SERVICE BULLETIN

PURPOSE : INFORMATION	ISSUE NO. : MSB-07E42-009	DATE : 2007-07-20
SUBJECT : REPLACEMENT PROCEDURE FOR WELDED PANEL AND INSTRUCTIONS FOR UNDERBODY ANTICORROSION AGENT	<div> <div><MODEL></div> <div>(EUR/Russia)</div> <div>OUTLANDER</div> <div>(GS45X)(CW0W)</div> </div> <div> <div><M/Y></div> <div>08</div> </div>	
GROUP : BODY

This Service Bulletin contains the following change and addition to the applicable Workshop Manual.

- According to the revision of the position to fill with the sound dampening foam material, the replacement procedure for the welded panel has been modified.
- The instructions for the underbody anticorrosion agent application have been added.

SIDE SILL

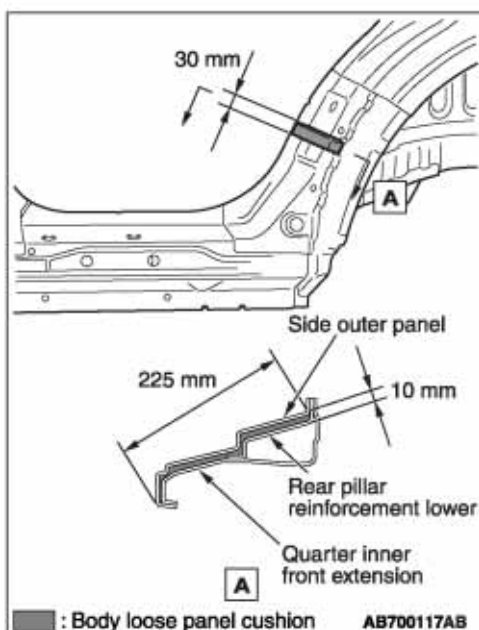
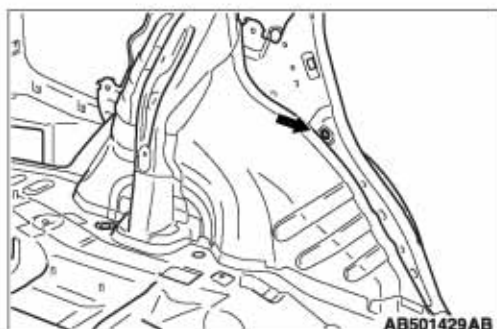
The installation procedure has been added.

The items other than below are the same as before.

When installing the new floor side sill outer, the inside of wheel arch cannot be filled with sound dampening foam material, therefore, machine the body loose panel cushion (MR435765 or MR565301) shown in the figure as an alternative and adhere it.

After installing the floor side sill outer, seal the hole and flange with bolt and aluminium tape, and then fill the hole with the sound dampening foam material as shown in the figure of the instructions.

**Sound dampening foam material: 3M ATD
ULTRAPRO Panel foam-Yellow**

QUARTER OUTER

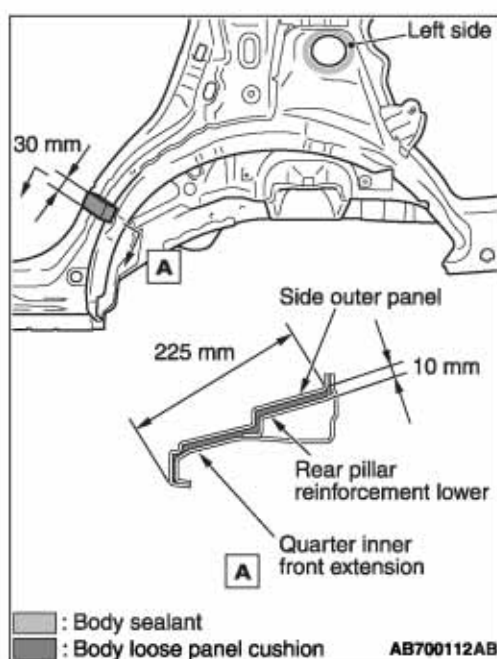
The position and the size of the body loose panel cushion that is installed when installing the rear quarter outer panel have been changed as below.

QUARTER INNER

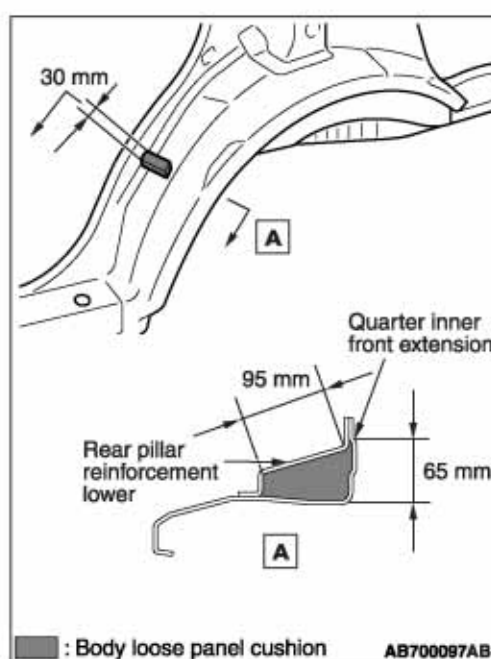
The position and the size of the body loose panel cushion that is installed when installing the rear pillar reinforcement lower have been changed as below.

UNDERBODY ANTICORROSION AGENT LOCATIONS <SOME AREAS>

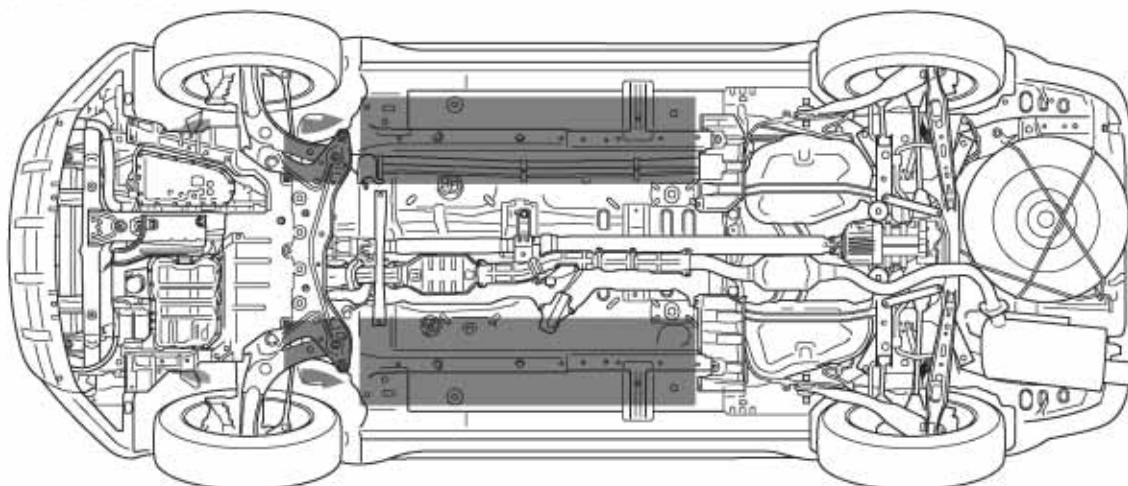
In order to provide a greater corrosion resistance, underbody corrosion prevention treatment should be performed after undercoat application. After completing body repairs, restore this underbody corrosion prevention treatment as indicated in the illustration if necessary. Recommend wax:

- Take care not to permit the anticorrosion agent to come in contact with body painting, brake parts, exhaust pipes, bearing seals for rear axle and rambler parts (such as tires and drive shaft boots).
- If anticorrosion agent gets onto the oxygen sensor, it will cause a drop in the performance of the sensor. Cover the oxygen sensor with a protective material when applying anti-corrosion agents and undercoats.

- Tectyl 506T, 506 or S
- Waxoyl
